Access Compliance Report

Public Rights-of-Way

(Curb Ramps)

Intersection ID: 3579	Main Street: KENT_VILLAGE_DR	Cross Street: SAXONBURY_WY	Location: S
ADA ID: ACAF55C7C8CA	Ramp Type: Perp	Initial Pass/Fail: Fail	Overall Compliance: No
Severity Score: 12.5			
Codes/Mitigation Info/Possible Solution		Field Measurements/Component Compliance

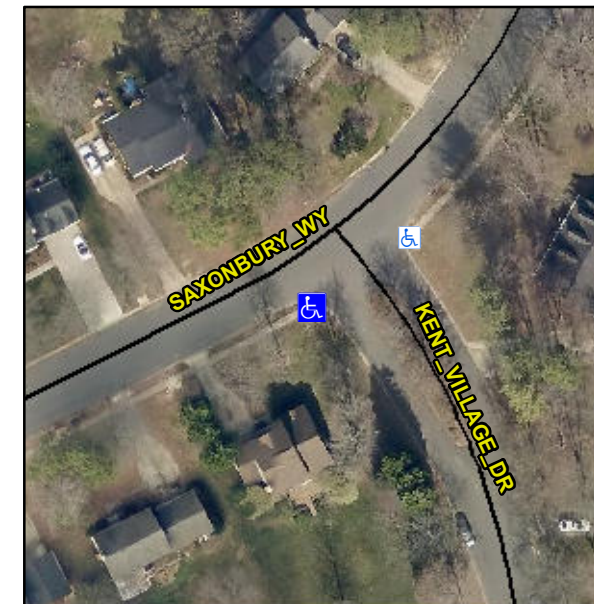
Not Found, R304.2.2

Compliance	Description	Data	Compliance	Description	Data
N/A	Ramp Length (in)	53.0	No	Ramp Slope (%)	9.0
Yes	Ramp Width (in)	48.0	Yes	Ramp XSlope (%)	1.1
N/A	Flare Type LT	N/A	N/A	Flare Type RT	N/A
N/A	Flare Slope LT (%)	N/A	N/A	Flare Slope RT (%)	N/A
N/A	Flare Traversable LT?	N/A	N/A	Flare Traversable RT?	N/A
N/A	Landing Length (in)	N/A	N/A	DWS Provided?	N/A
N/A	Landing Width (in)	N/A	N/A	DWS Contrast?	N/A
N/A	Landing Slope (%)	N/A	N/A	DWS Length (in)	N/A
N/A	Landing X Slope (%)	N/A	N/A	DWS Full Width?	N/A
N/A	Landing Curb? (Y/N)	N/A	N/A	DWS Offset (in)	N/A
N/A	Shared Landing?	N/A			
N/A	Gutter Ponding?	N/A	N/A	Gutter Slope (%)	N/A
N/A	Gutter Lip Ht (in)	N/A	N/A	Gutter X Slope (%)	N/A
N/A	Painted X Walk1?	No	N/A	Painted X Walk2?	N/A
	X Walk 1 Direction	To NE		X Walk 2 Direction	N/A
N/A	X Walk 1 Width (in)	N/A	N/A	X Walk 2 Width (in)	N/A
	X Walk 1 Slope (%)	2.8		X Walk 2 Slope (%)	N/A
	X Walk 1 X Slope (%)	4.0		X Walk 2 X Slope (%)	N/A

Remove & Replace Entire Ramp.
